Item 8.**Section 4.55 Application: 93-97 Macquarie Street, Sydney - D/2017/1609/A****File Number:** D/2017/1609/A**Summary**

Date of Submission:	7 May 2024
Amended plans/Additional information	2 May 2025 and 2 June 2025
Applicant:	The Planning Studio
Architect/Designer:	BVN
Developer:	Census Advisory
Owner:	Macquarie Street Development Pty Ltd
Planning Consultant:	The Planning Studio
Heritage Consultant:	Weir Phillips
Cost of Works:	\$183,035,738.56
Zoning:	The site is zoned SP5 Metropolitan Centre under the Sydney Local Environmental Plan 2012. The indicative use is defined as a 'mixed use development', comprising 'residential accommodation', 'commercial premises' and 'food and drink premises', all of which are permissible with consent.
Proposal Summary:	This Section 4.55(2) modification application seeks to amend the concept consent for the redevelopment of the 'Stamford Hotel' building and adaptive reuse of the existing Heritage item known as the Health Building. Specifically, modifications are proposed to the concept envelope, including a minor reduction to the podium and tower setbacks on the north, east and southern boundaries, an increase in the overall height by 2.84 metre

Figure 38: Extract from the concept section showing extent of additional excavation

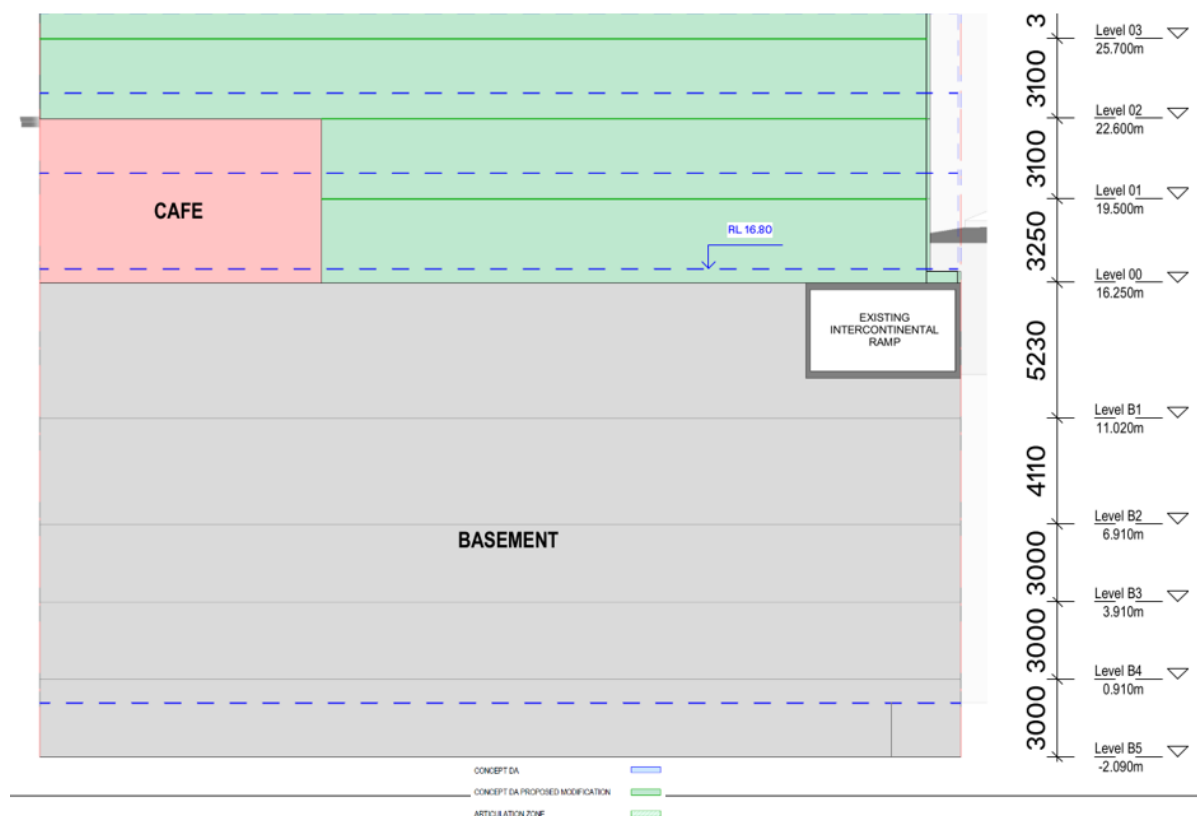
119. It is proposed to increase the depth of the basement by approximately 2 metres as shown in Figure 38, below. The increase in the depth is to accommodate the new basement of the concurrent Detailed Design DA, that is centrally located and services the basements, the heritage building, and the new residential tower.

120. The increase in the basement depth is entirely below ground and will not be visible from adjoining properties or the public domain. The additional excavation will be primary towards the western side of the basement as it will level out the current 'zigzag' basement.
121. The proposed basement footprint is demonstrated by the Detailed Design DA as necessary to accommodate the consolidated internal circulation core, while accommodating the substation and other loading and servicing requirements of the proposed development. The additional excavation is considered acceptable by the submitted geotechnical report and the associated additional demolition to the heritage item is also considered acceptable by the submitted heritage impact statement and the City's Heritage Specialist. The proposed changes to the basement envelope are considered acceptable.
